Contract No. EP/SP/66/12

Integrated Waste Management Facilities, Phase 1

Landscape and Visual Plan

KSZHJV	/	312	/	LVP	/	0001	/	F
Issuer		Project Code		Type of Document		Sequential No.		Revision Index

Figure 6.6 Visual appearance of the Breakwaters

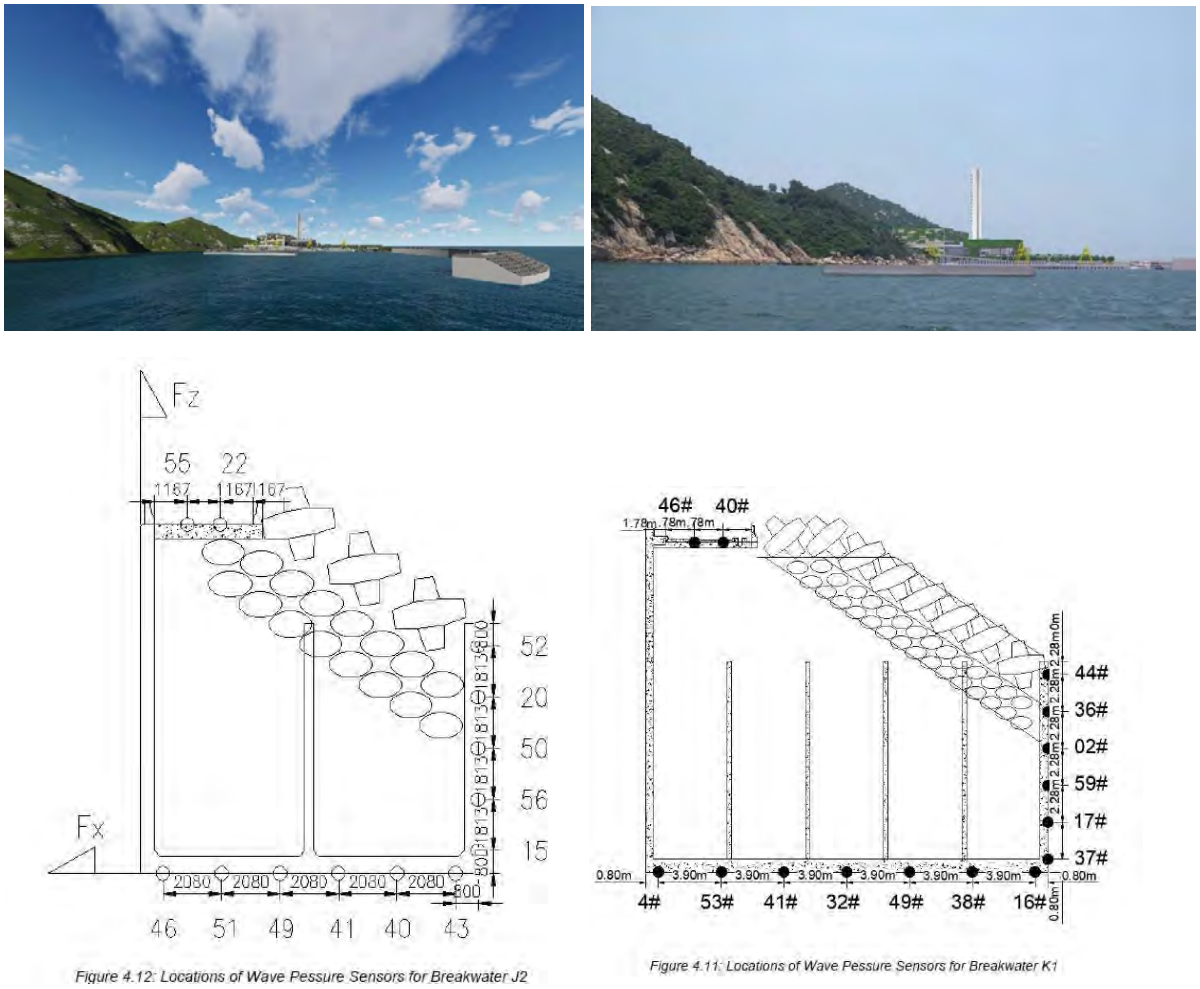
6.	Section 6. 7 - The design of the breakwaters is unclear from the distant view in Figure 6.6. Please provide reference	Section 6.7 is revised to include references to the High Island Reservoir interlocking precast concrete armouring units for reference.
